Product Change Notification / ASER-23WWAI681

CCB 4235 Final Notice: Qualification of MMT as a new final test site for selected Atmel AT27C/BV/LVxxxPU/JUxxx products

PCN # ASER-23WWAI681
CCB 4235_Pre and Post Change Summary

32L PLCC Tube Packing: MPHL

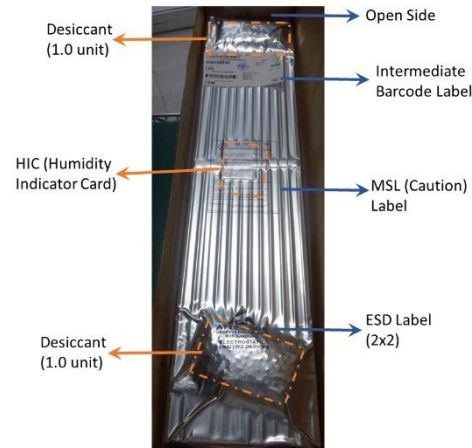
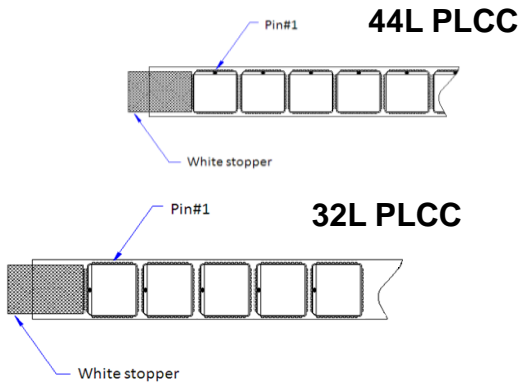
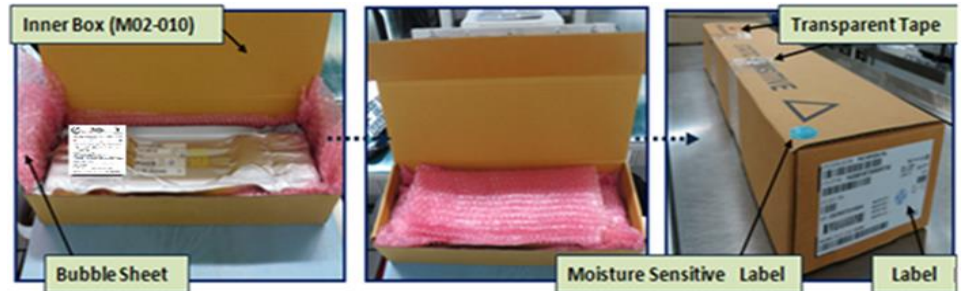
32L PLCC Tube Packing : MMT

PLCC 32 CARRIER TAPE

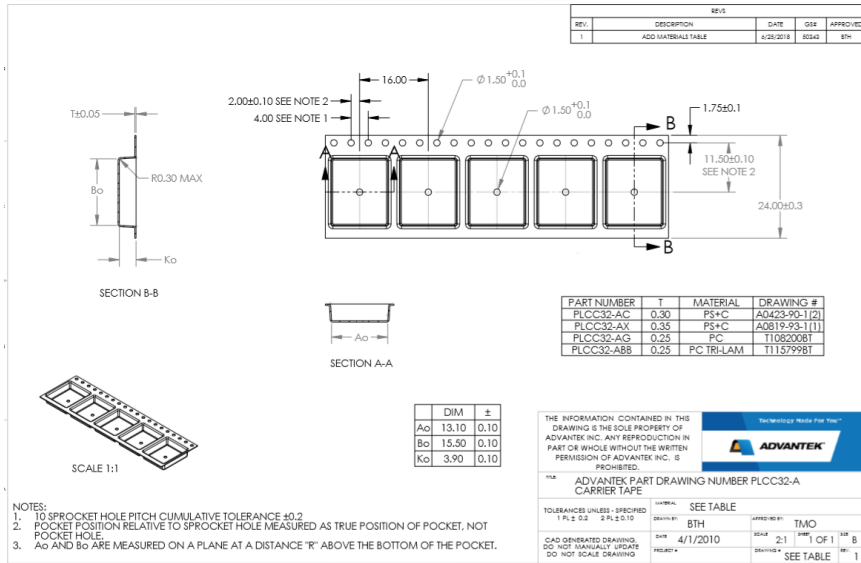
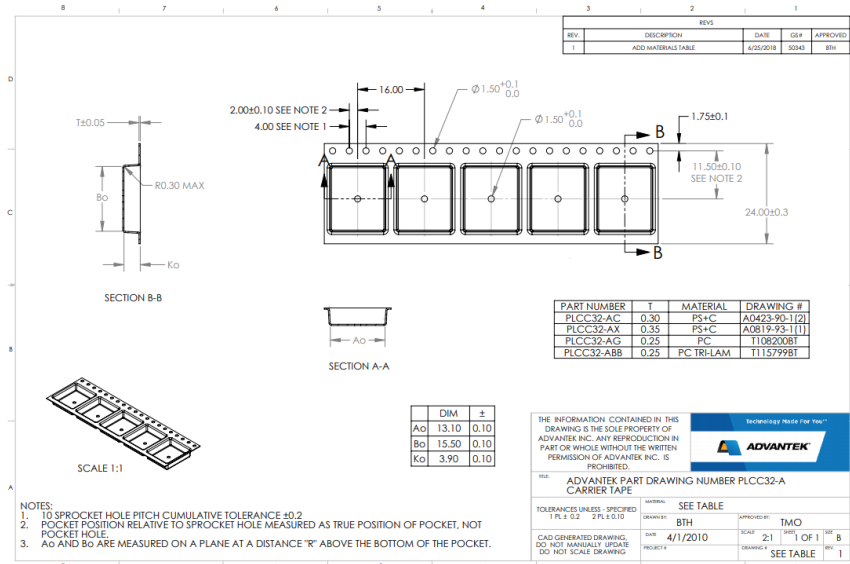
Supplier	Mfg. Part No.	W (mm.) ± 0.3 or Specific	P (mm.) ± 0.1 or Specific	A ₀ ± 0.1 or Specific	B ₀ ± 0.1 or Specific	K ₀ ± 0.1 or Specific	Thickness
Advantek	PLCC32-AC170.P1	24	16	13.10/-0.1	15.50+/-0.1	3.90+/-0.10	-

Supplier	Mfg. Part No.	W (mm.) ±0.3 or Specific	P (mm.) ±0.1 or Specific	A ₀ ±0.1 or Specific	B ₀ ±0.1 or Specific	K ₀ ±0.1 or Specific	Thickness
Advantek	PLCC32-AC170.M1	24	16	13.10/-0.1	15.50+/-0.1	3.90+/-0.10	0.30 +/-0.05

PLCC 44 CARRIER TAPE

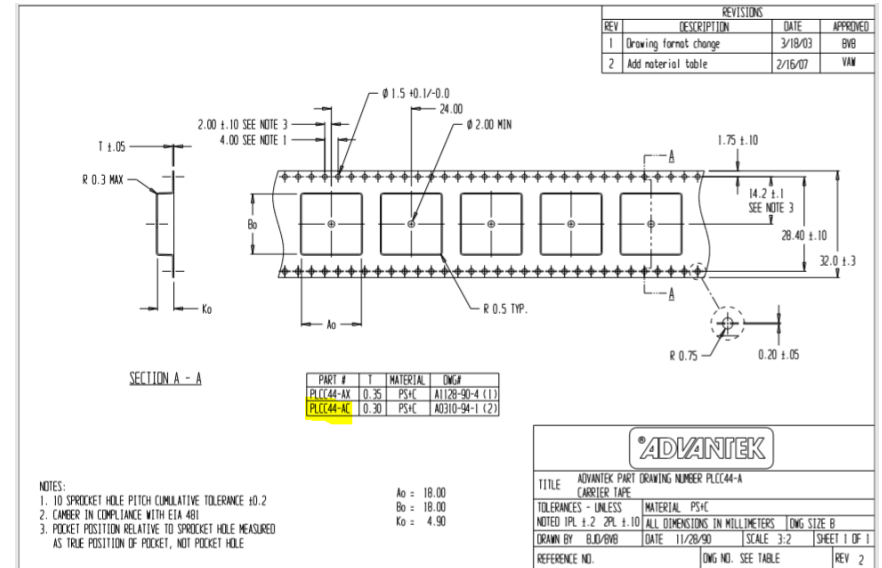
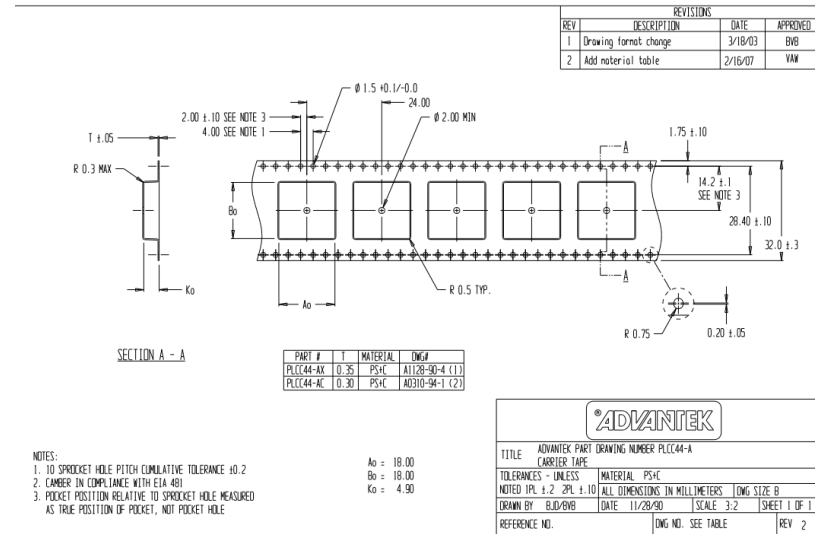
Supplier	Mfg. Part No.	W (mm.) ± 0.3 or Specific	P (mm.) ± 0.1 or Specific	A ₀ ± 0.1 or Specific	B ₀ ± 0.1 or Specific	K ₀ ± 0.1 or Specific	Thickness
Advantek	PLCC44-AC88.0R5	32	24	18+/-0.1	18+/-0.1	4.9+/-0.1	-

Supplier	Mfg. Part No.	W (mm.) ±0.3 or Specific	P (mm.) ±0.1 or Specific	A ₀ ±0.1 or Specific	B ₀ ±0.1 or Specific	K ₀ ±0.1 or Specific	Thickness
Advantek	PLCC44-AC88.0R5	32	24	18+/-0.1	18+/-0.1	4.9+/-0.1	0.30 +/-0.05

PLCC 32 COVER TAPE (Width: 24mm)

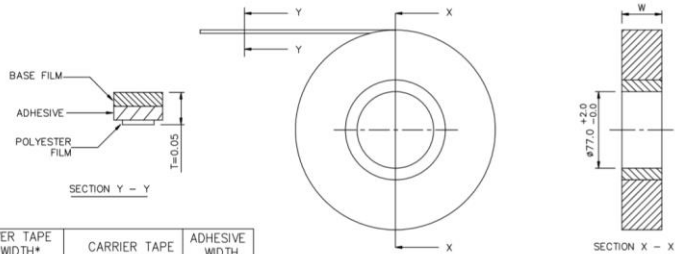
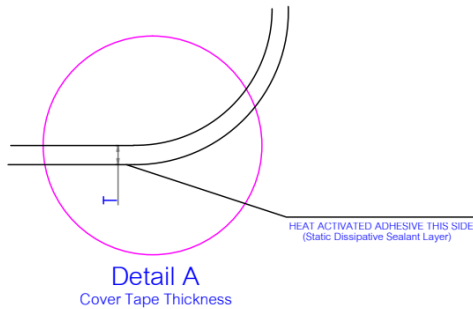
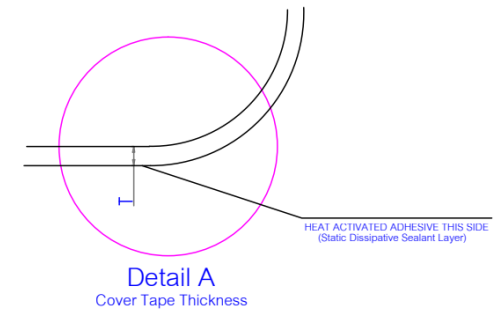
Carrier Width	Supplier	MCHP P/N	Supplier Part	Width "W" (mm)	Thickness (mm)	Sealing Mythology
24mm	CPak	211894	CP58 PSA	21.3 +/-0.1	0.050 ±0.010	Pressure Seal

Carrier Width	Supplier	MCHP P/N	Supplier Part	Width "W" (mm)	Thickness (mm)	Sealing Mythology
24mm	Sumitomo	22102002	CSL-Z7302	21.0 +/- 0.1	0.050 ±0.010	Heat Sealing

PLCC 44 COVER TAPE (Width: 32mm)

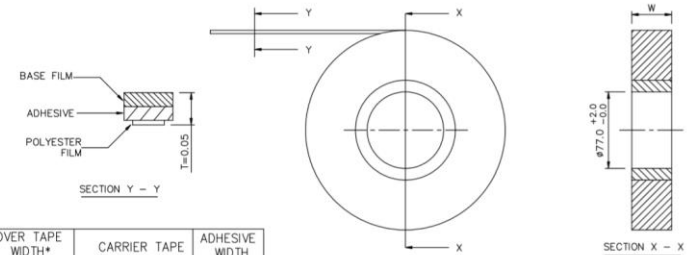
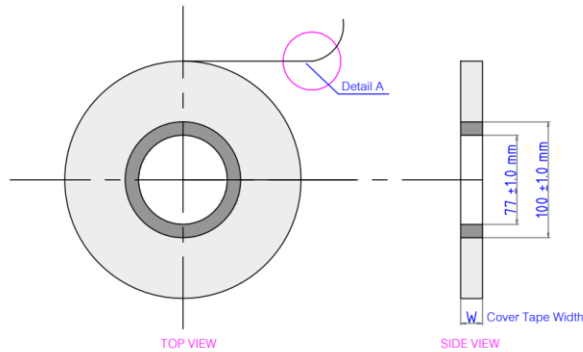
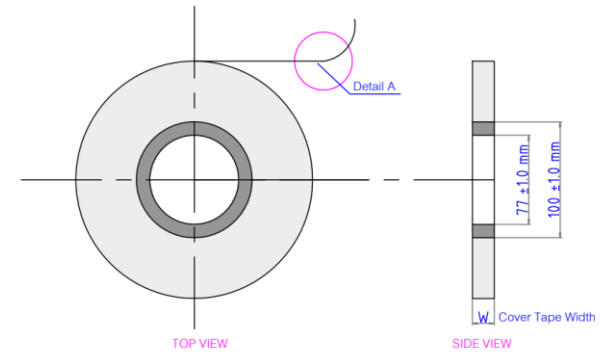
Carrier Width	Supplier	MCHP P/N	Supplier Part	Width "W" (mm)	Thickness (mm)	Sealing Mythology
32mm	CPak	211887	CP58 PSA	25.5 +/-0.1	0.050 ±0.010	Pressure Seal

Carrier Width	Supplier	MCHP P/N	Supplier Part	Width "W" (mm)	Thickness (mm)	Sealing Mythology
32mm	Sumitomo	22104401	CSL-Z7302	25.5 +/- 0.1	0.050 ±0.010	Heat Sealing

PLCC 32L

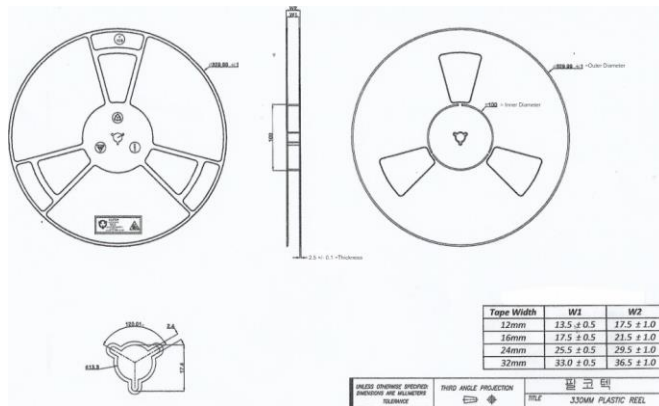
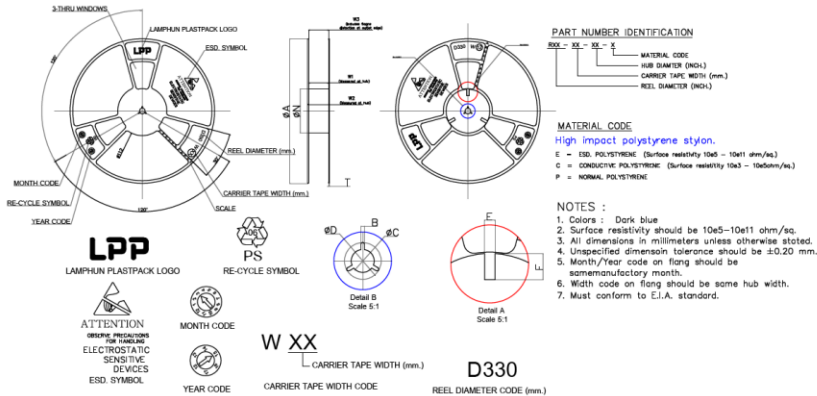
Width	MCHP P/N	Supplier Part	Hub	Color
24mm	211696	N/A	4inch (100mm)	White

Description	MPHIL	MMT
Color	White	Dark blue
Diameter	329.99 +/- 1.0	330 +/- 2.0
Hub	100	100 +/- 2.0
Width	25.5 +/- 0.5	24.4 +/- 2.0

Width	MCHP P/N	Supplier Part	Hub	Color
24mm	23000024	R13-24-04-E	4inch (100mm)	Dark Blue

PLCC 44L

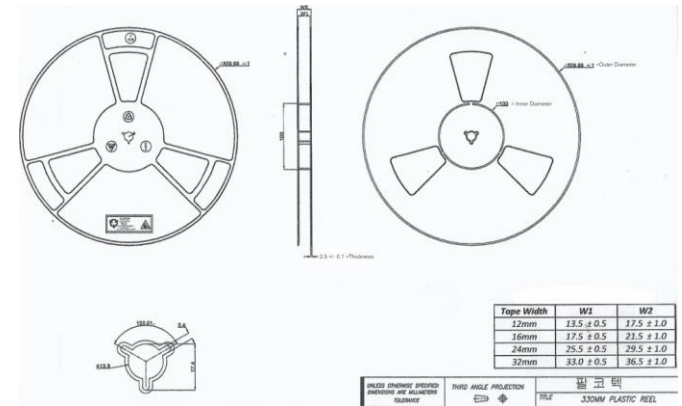
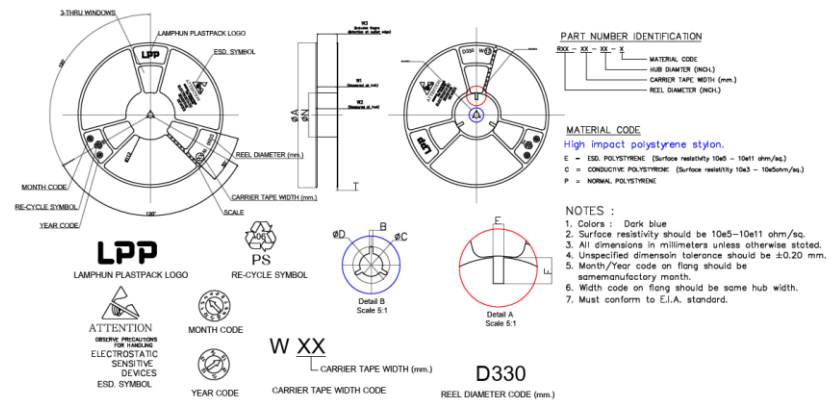
Width	MCHP P/N	Supplier Part	Hub	Color
32mm	211697	N/A	4inch (100mm)	White

Description	MPHIL	MMT
Color	White	Dark blue
Diameter	329.99 +/- 1.0	330 +/- 2.0
Hub	100	100 +/- 2.0
Width	33 +/- 0.5	32.4 +/- 2.0

Width	MCHP P/N	Supplier Part	Hub	Color
32mm	23000023	R13-32-04-E	4inch (100mm)	Dark Blue

TAPE AND REEL PACKING PROCEDURE MPHL

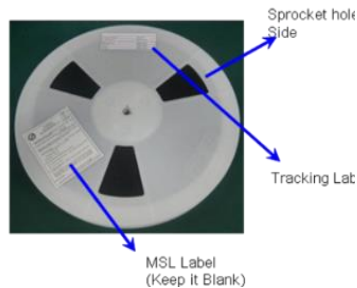
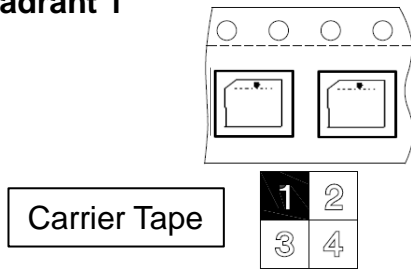
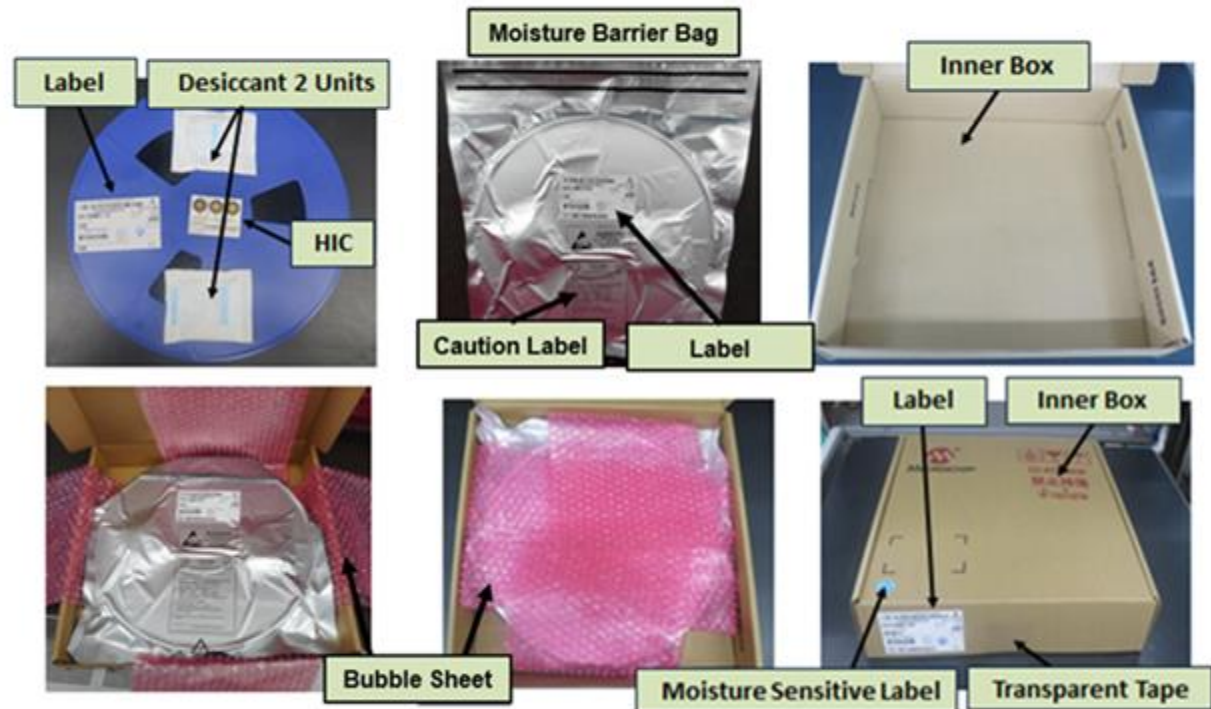
MSL 2 – T/R REEL DRY PACK PROCEDURE (Ref Spec# PI-35015)

MSL 2 – T/R REEL DRY PACK PROCEDURE (Ref Spec# PI-24069)
